MEMORANDUM

RE: DRH11-00133 / Glenn Levie / 1005 W. Royal Boulevard (Appeal)

Boise Green Investors appealed the Design Review Committee's approval of a 108 unit, three-story apartment building located at 1005 W. Royal Boulevard in an R-ODD (Residential Office with Design Review) zone.

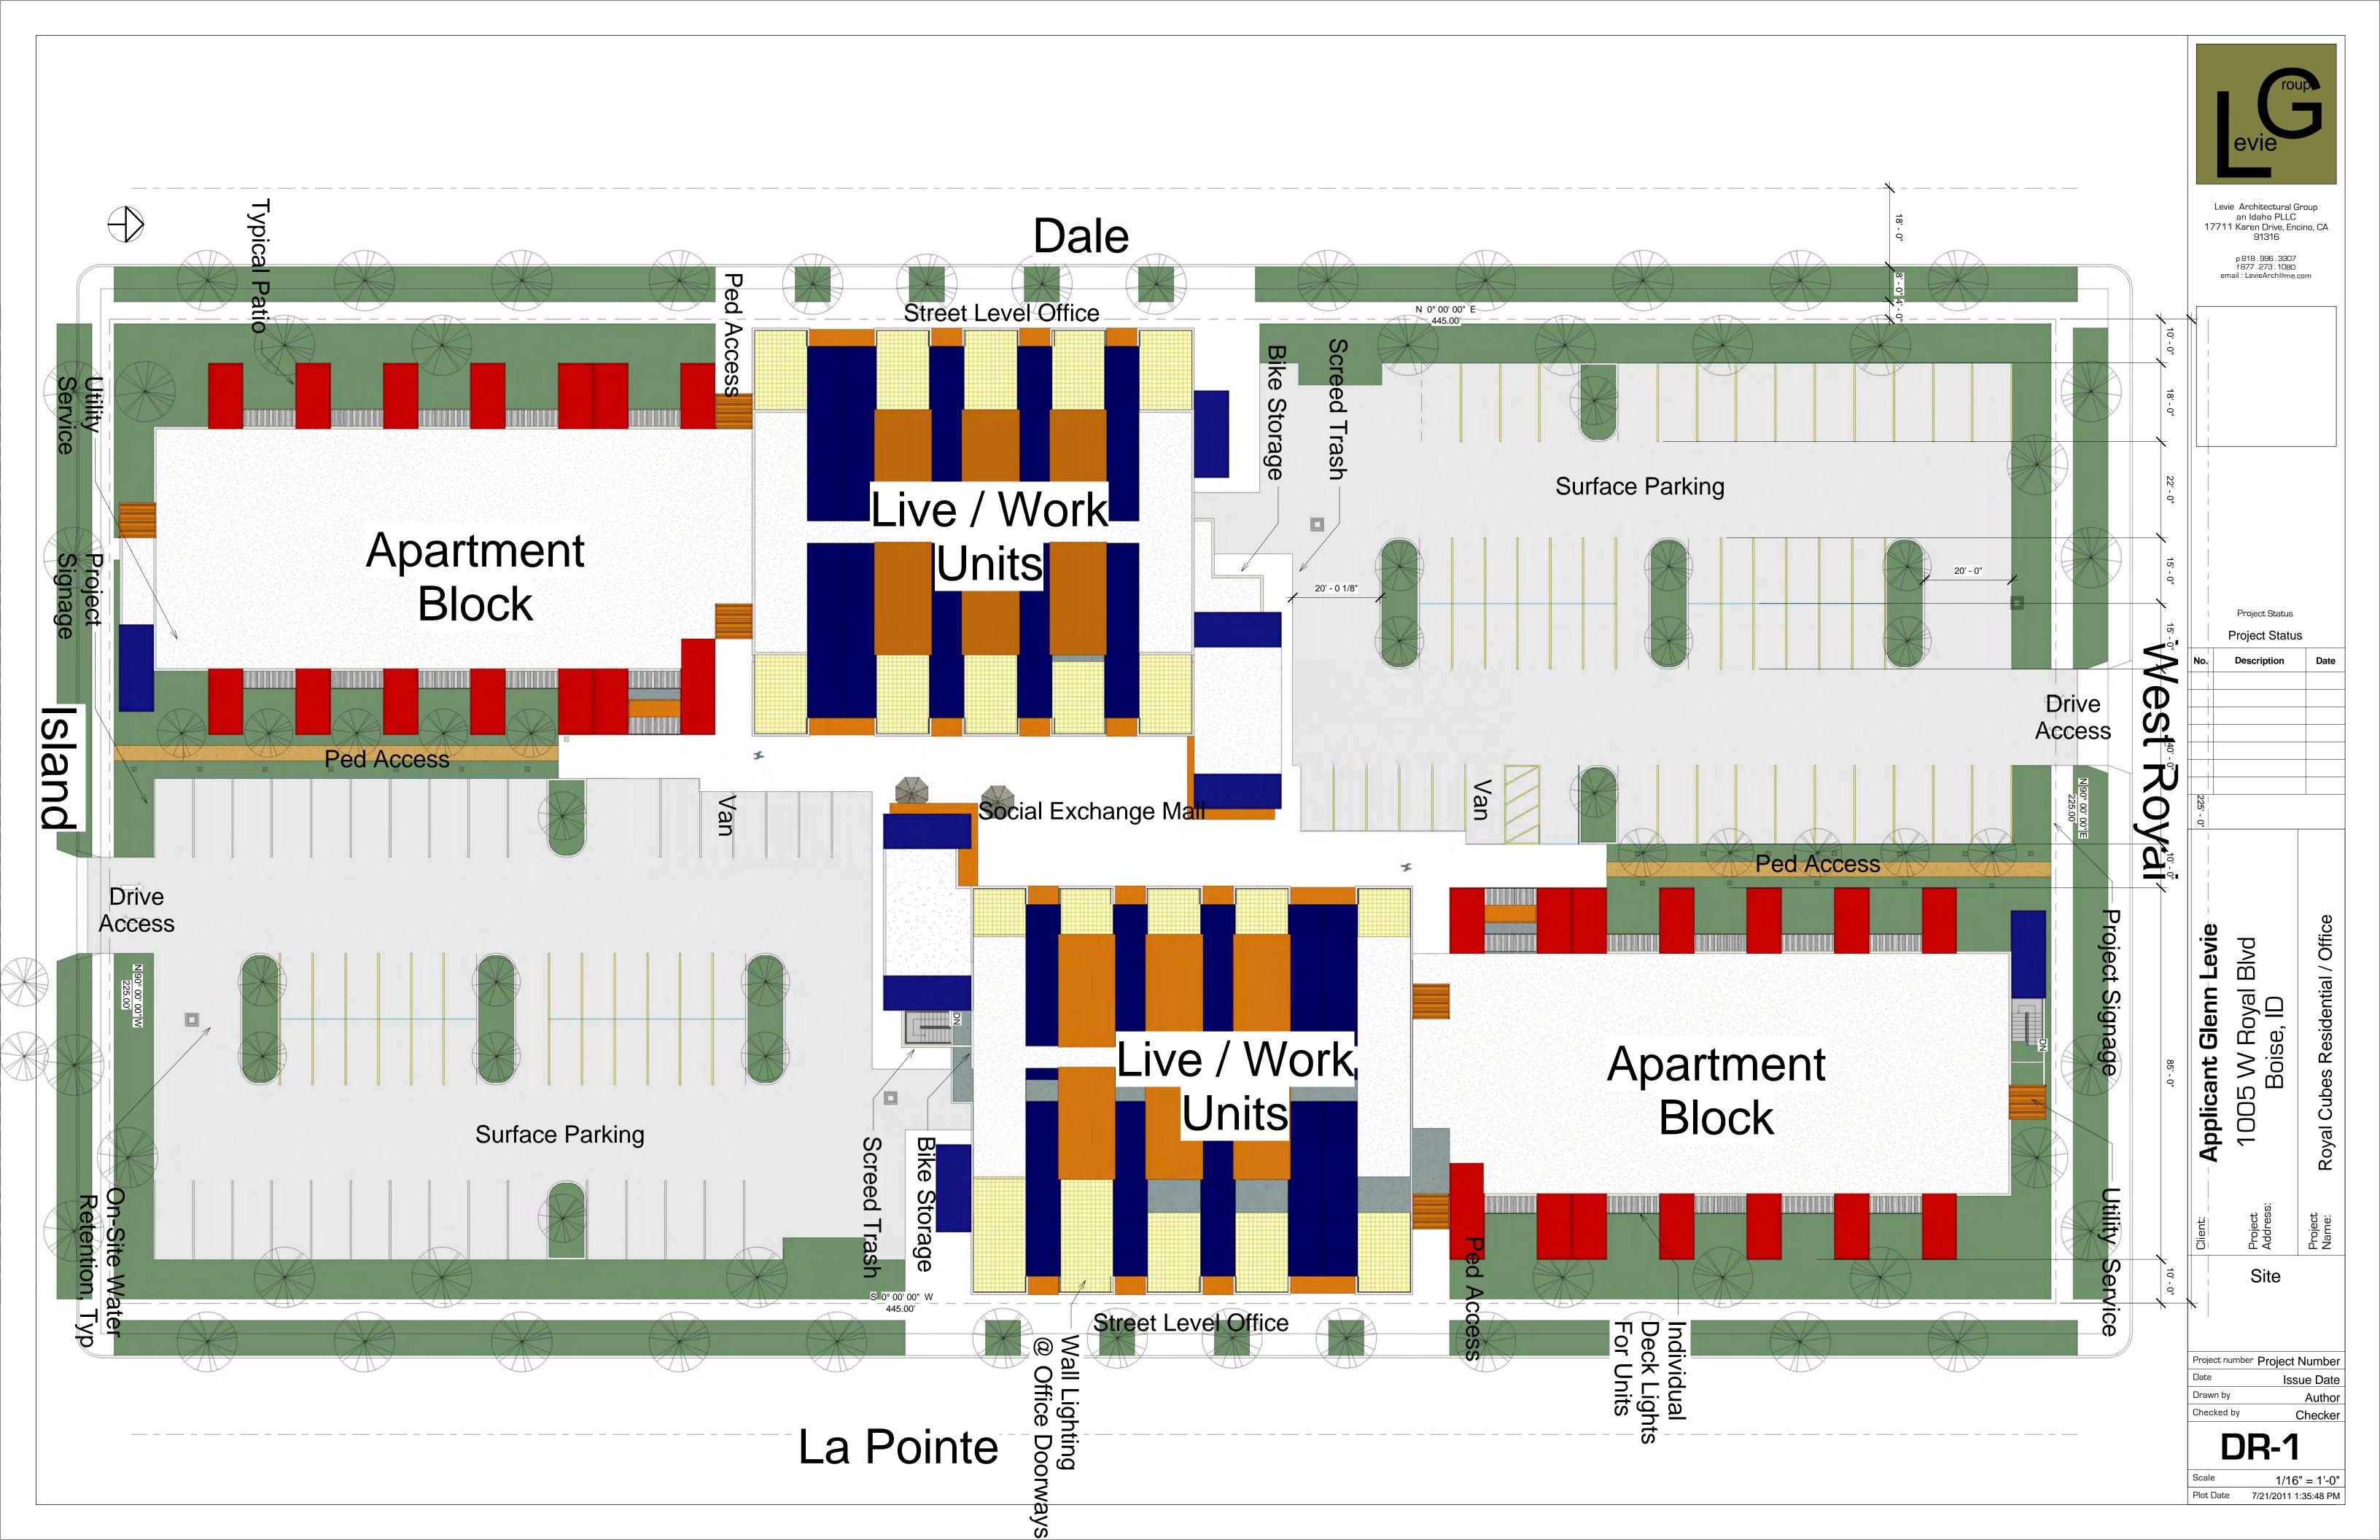
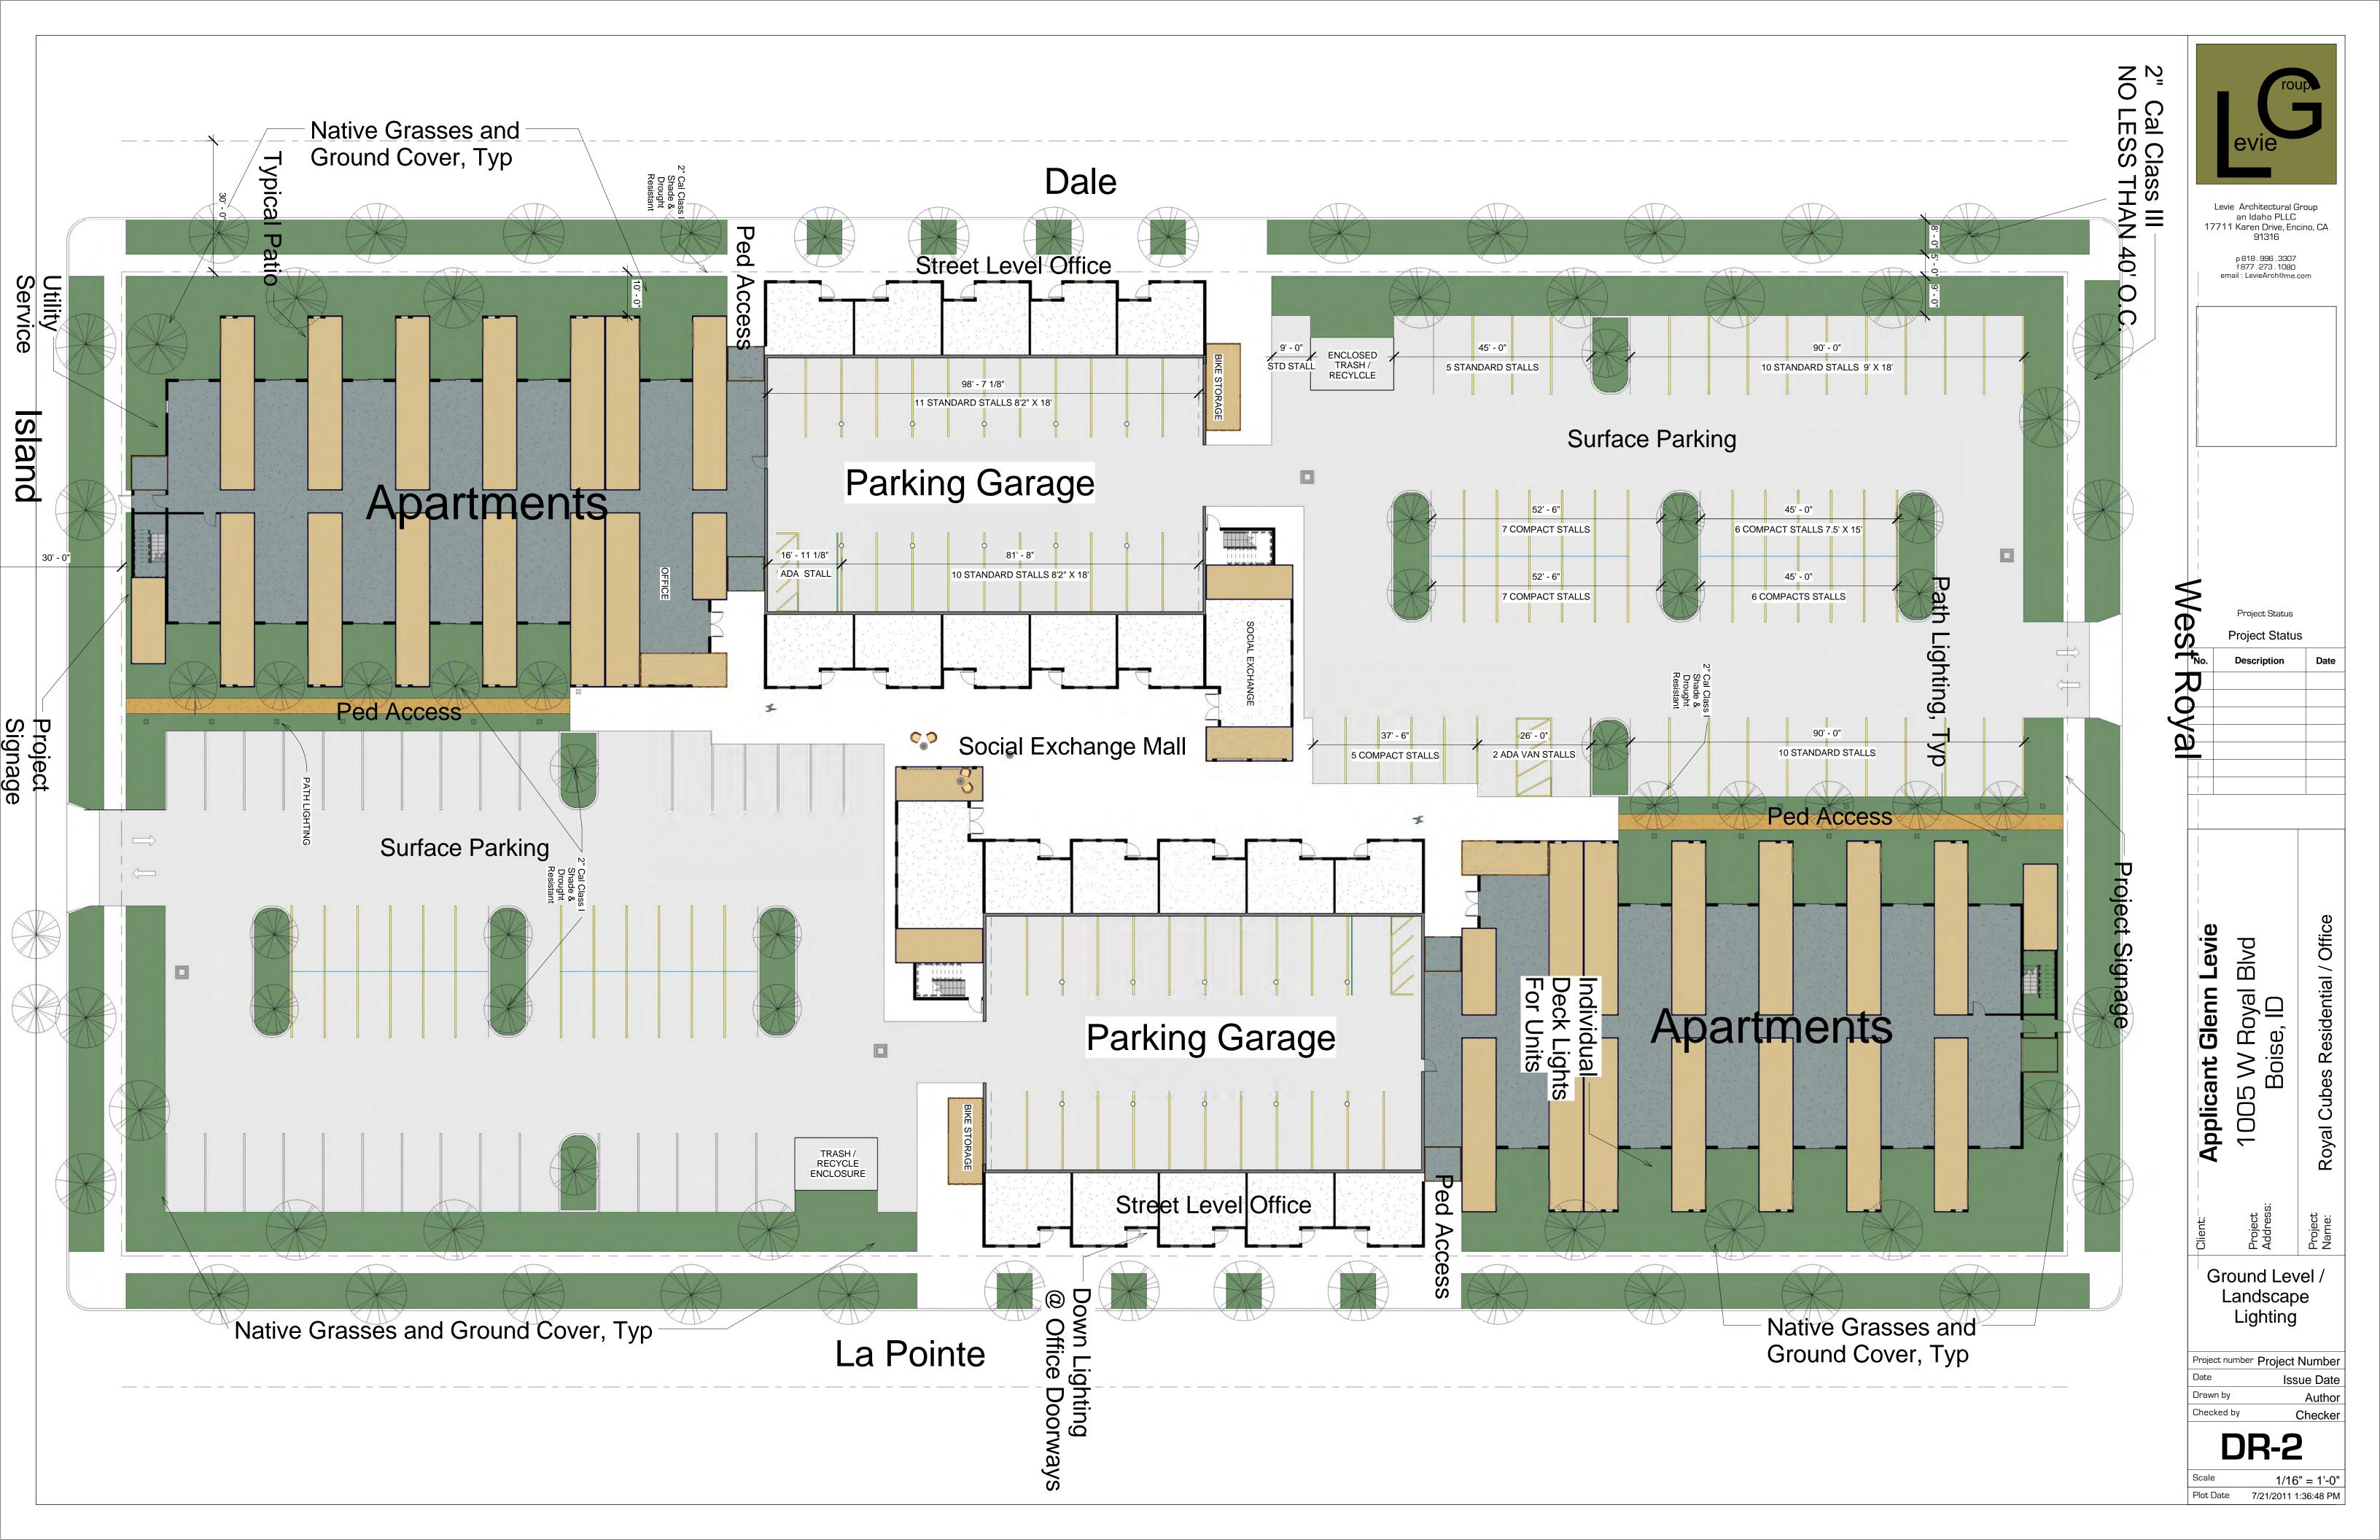
The landscape plan conceptual with this submittal. Very basic concepts which include native grasses and ground cover as well as some tree placing have been proposed. Further development of the landscape plan is needed to ensure compliance with the Landscape Ordinance.

A less than 10% parking reduction has been requested by the applicant. The project will provide 1.5 parking spaces per unit. The spaces not proposed for the site are the ones in the ordinance for guest parking. With the transit in the vicinity, greenbelt, on-street parking and the fact that all of the units are only one bedroom, approval of the parking reduction should be granted.
